AMENDMENTS TO THE DRAWINGS

REMARKS / ARGUMENTS

FIG. 12

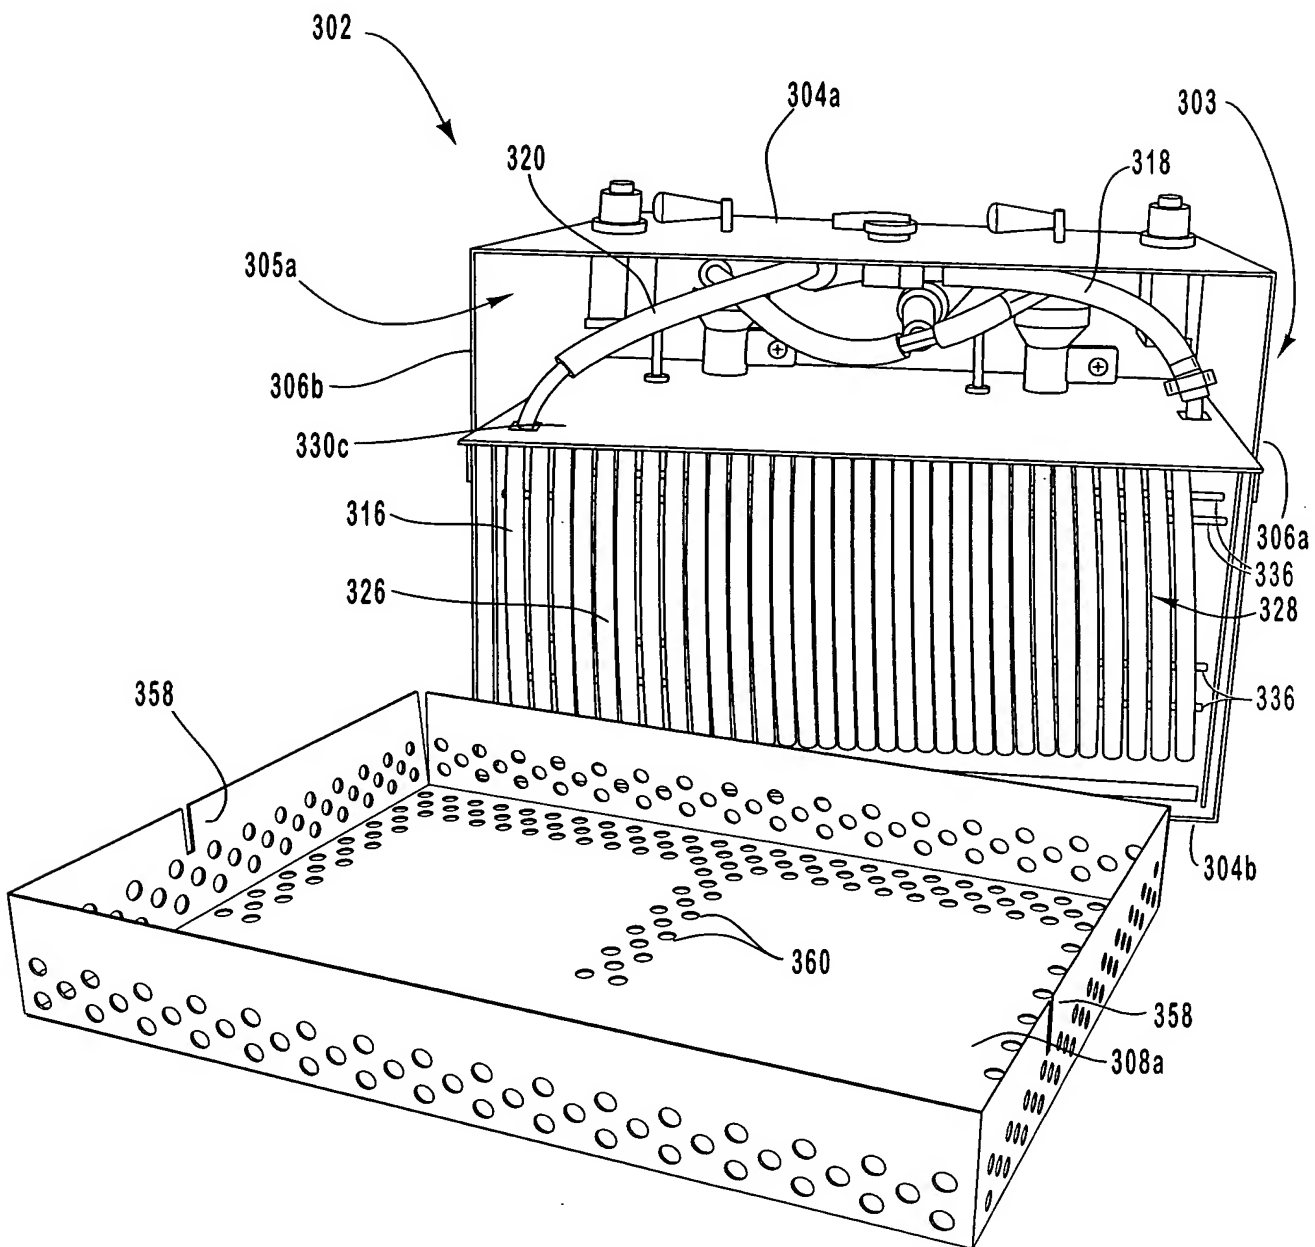
The attached sheets of drawings include changes to Figures 12 and 13. These sheets replace the previous sheets, including Figures 12 and 13, submitted with the Response to the Notice to File Missing Parts filed November 10, 2004. Figures 12 and 13 now include reference character 336 inadvertently left off. No new matter is added by Figures 12 and 13, which is supported in the specification as originally filed.

In the Office Action, the Examiner objected to the drawings under 37 C.F.R. § 1.84(p)(5) as not including a reference sign for support rods 336 mentioned in the description. Applicant respectfully submits that the support rods 336 are shown in Figure 13 of sheet 12 of the annotated sheets filed November 10, 2004, but the reference character was inadvertently left off of the Replacement Sheet filed the same day. For clarity, reference character 336 has also been added to Figure 12.

Accordingly, Applicant has revised Figures 12 and 13 to include the reference character 336, as discussed above in the "AMENDMENTS TO THE DRAWINGS" section of this response. Applicant respectfully requests withdrawal of the objection to the drawings.
